HISTORIC AND DESIGN REVIEW COMMISSION

May 15, 2019

HDRC CASE NO: 2019-255
ADDRESS: 607 MASON ST
LEGAL DESCRIPTION: NCB 1264 BLK 3 LOT 10
ZONING: R-6, H
CITY COUNCIL DIST.: 2
DISTRICT: Government Hill Historic District
APPLICANT: Lisa Hendrickson
OWNER: Lisa Hendrickson/Verdant House LLC
TYPE OF WORK: Window repair, fenestration modifications, door replacement, roof replacement, foundation repair, fencing, rear deck construction and Historic Tax Certification
APPLICATION RECEIVED: April 29, 2019
60-DAY REVIEW: June 28, 2019
CASE MANAGER: Edward Hall
REQUEST:

607 Mason St.
SAITX, 78208
Exhibit 2

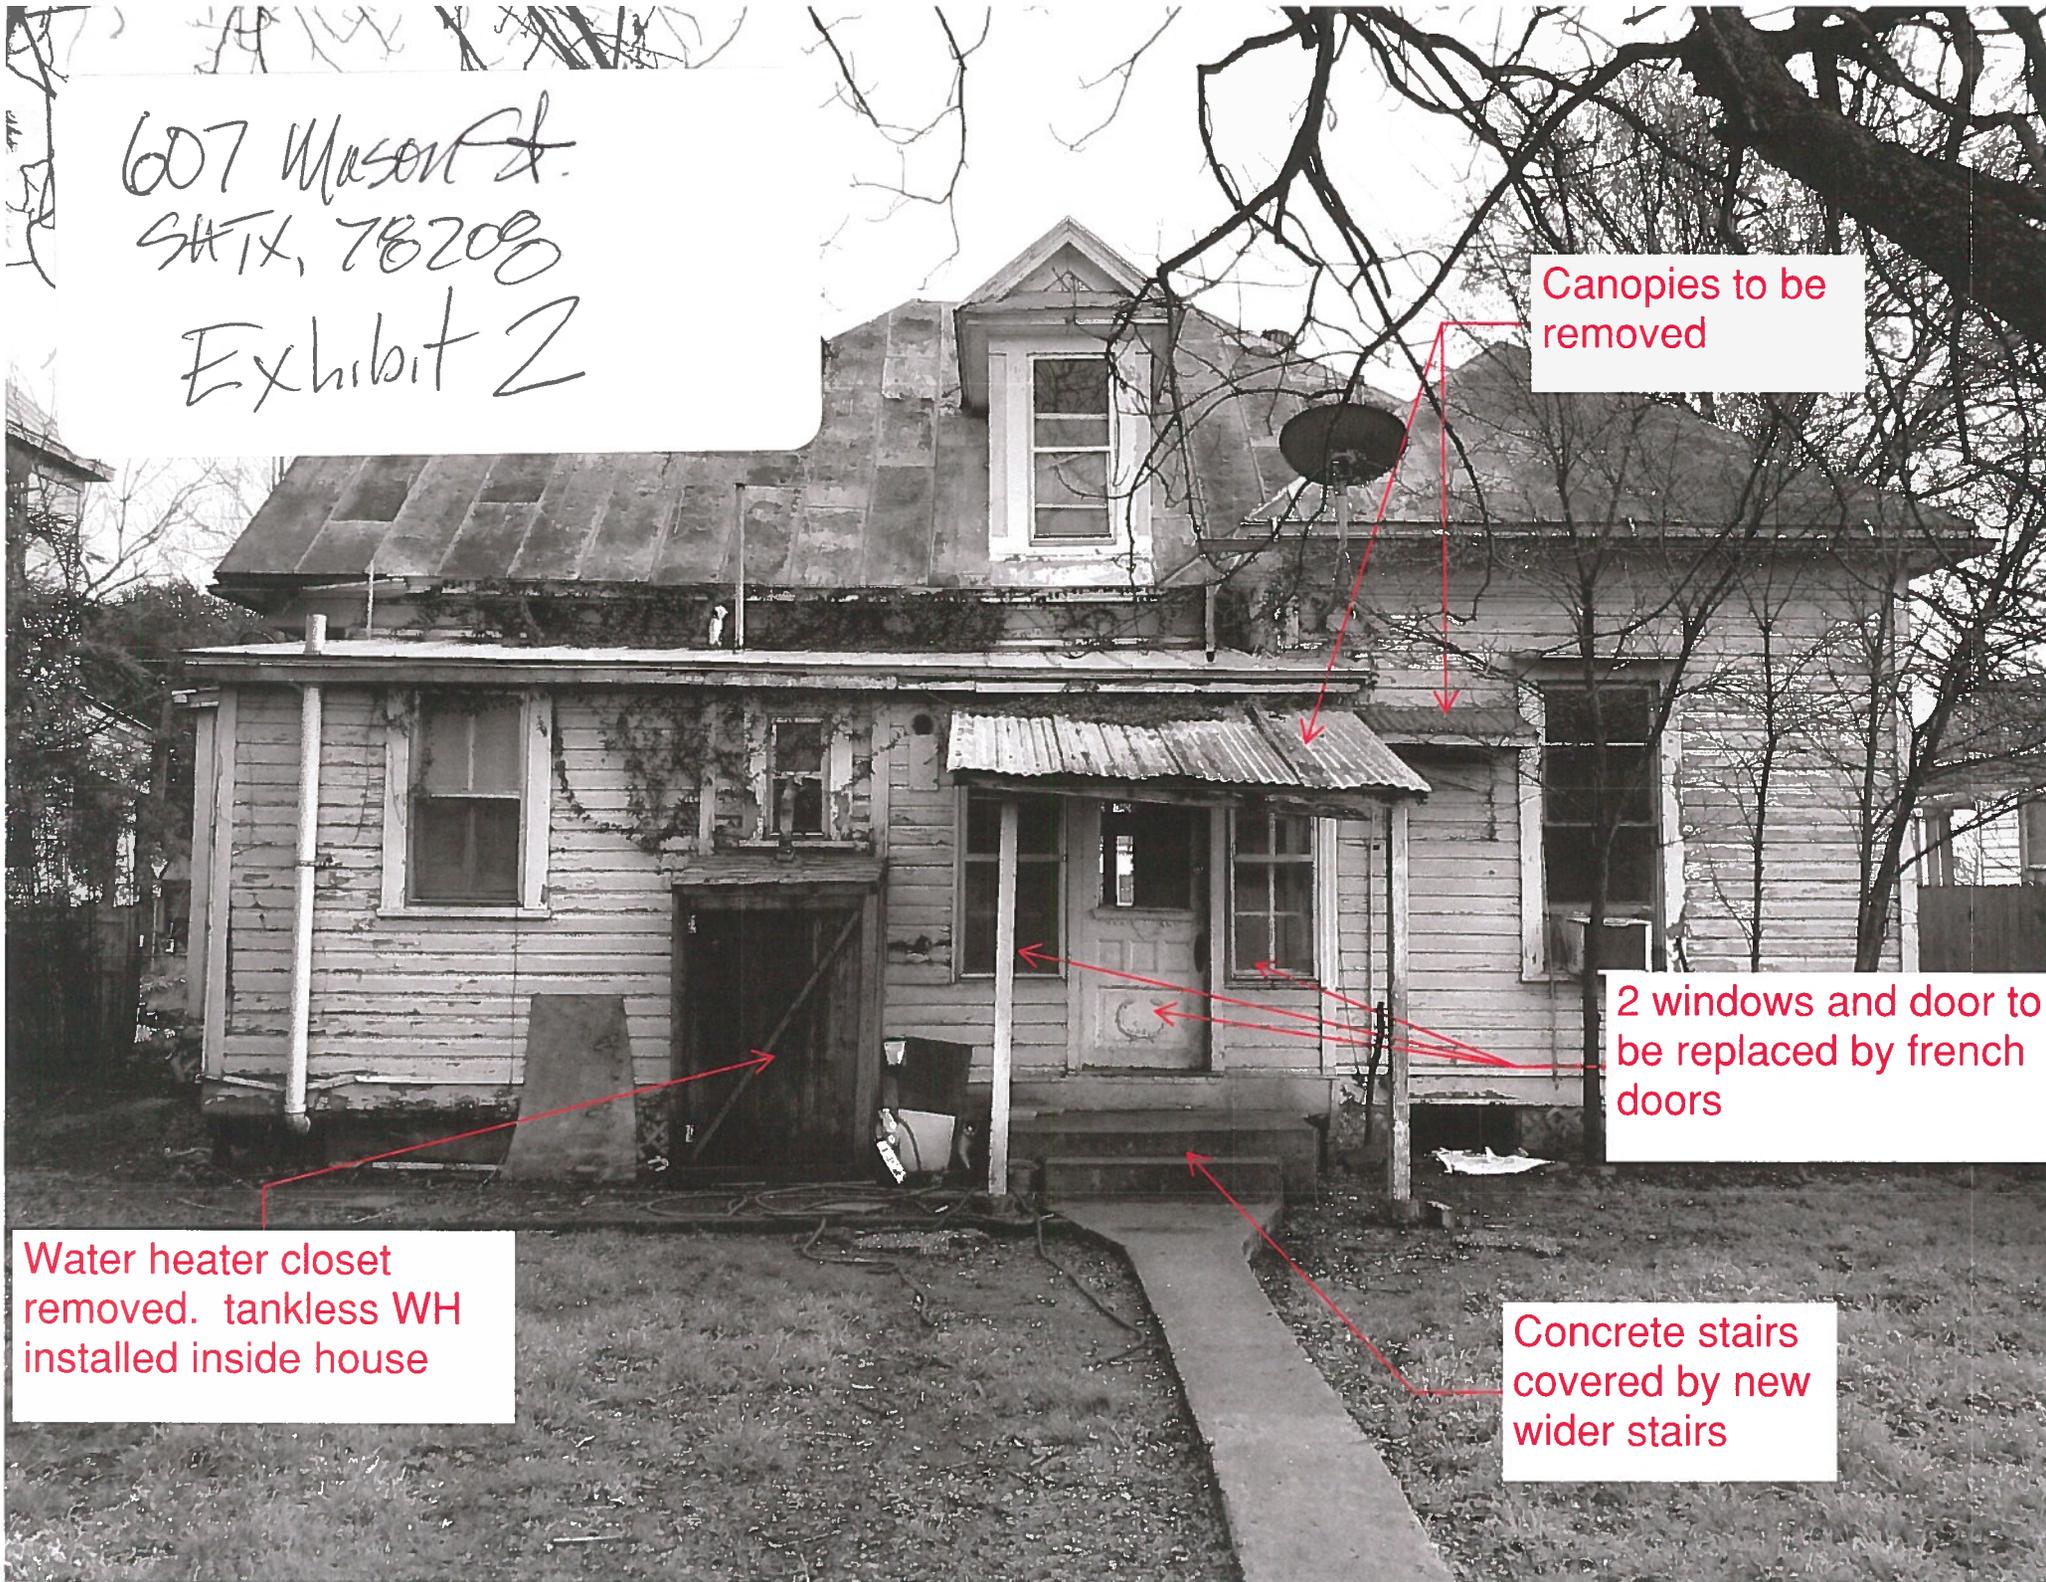
- g. REAR STEPS & WATER HEATER CLOSET – The rear elevation currently feature elements that are not original to the structure, including concrete steps and a water heater closet. The applicant has proposed to demolish the rear water heater closet and cover the existing, concrete steps with wood steps. Staff finds both scopes of work to be appropriate.

4. Staff recommends approval of item #4, the demolition of a rear water heater closet and rear step modifications as submitted.
5. Staff recommends approval of item #5, rear yard fencing and landscaping with the following stipulation:

Exhibit 6A
607 Mason St
SA 7X, 78208

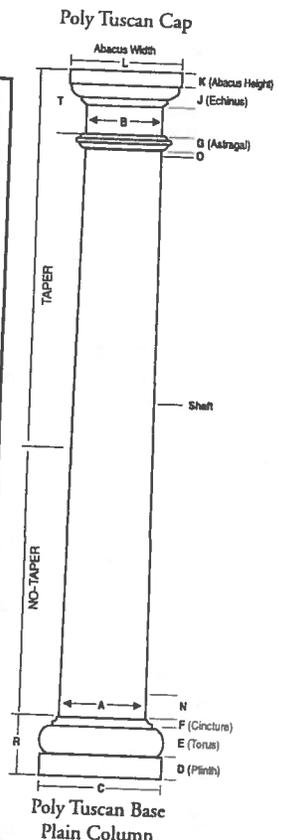
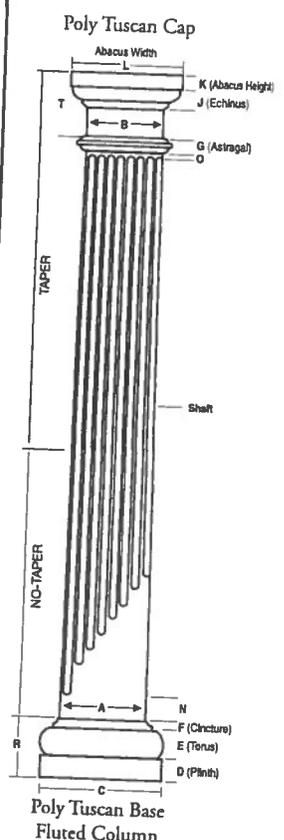
- f. PORCH COLUMNS – The historic structure currently features wrought iron porch columns, which are not original to the historic structure. The applicant has proposed to replace these columns with fiberglass columns of

the Doric order. The Guidelines for Exterior Maintenance and Alterations 7.B.iii. notes that replacement elements, such as columns should be replaced in-kind. When in-kind replacement is not possible, columns should feature compatible materials, textures, dimensions and finishes. Staff does not find the installation of fiberglass columns to be consistent with the Guidelines.

7. Staff does not recommend approval of item #7, the installation of fiberglass porch columns, based on finding f. Staff recommends that the applicant install wood porch columns that are consistent with the Guidelines.
